Tennessee Valley Authority, Post Office Box 2000, Soddy-Daisy, Tennessee 37384-2000

September 21, 2001

SEQUOYAH NUCLEAR PLANT (SQN) - UNITS 1 AND 2 - REVISION OF INSTRUMENTATION MEASUREMENT RANGE, BORON CONCENTRATION LIMITS, REACTOR CORE LIMITATIONS, AND SPENT FUEL POOL STORAGE REQUIREMENTS FOR TRITIUM PRODUCTION CORES (TPCs) - TECHNICAL SPECIFICATION (TS) CHANGE NO. 00-06

PROPOSED TECHNICAL SPECIFICATION (TS) CHANGE TS 00-06
AND TPBAR CONSOLIDATION ACTIVITY
DESCRIPTION AND EVALUATION OF THE PROPOSED CHANGE

Fig. 5.6-5 Limiting Burnup Requirements in Region 4, Checkerboard Array of 1 Fresh and 3 Type T Spent Fuel Assemblies

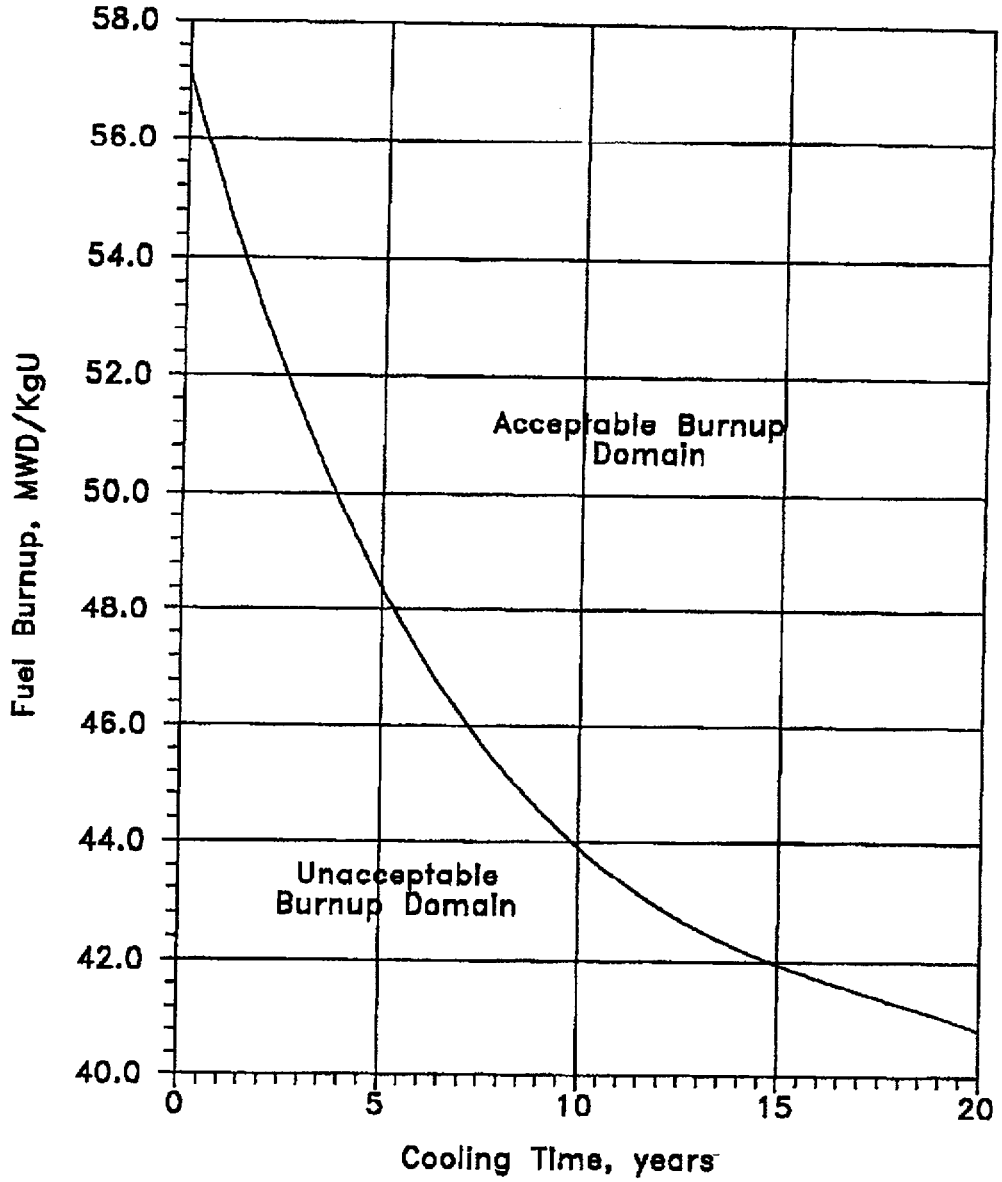
[Add Inserts 14, 15, and 16]

Insert 15
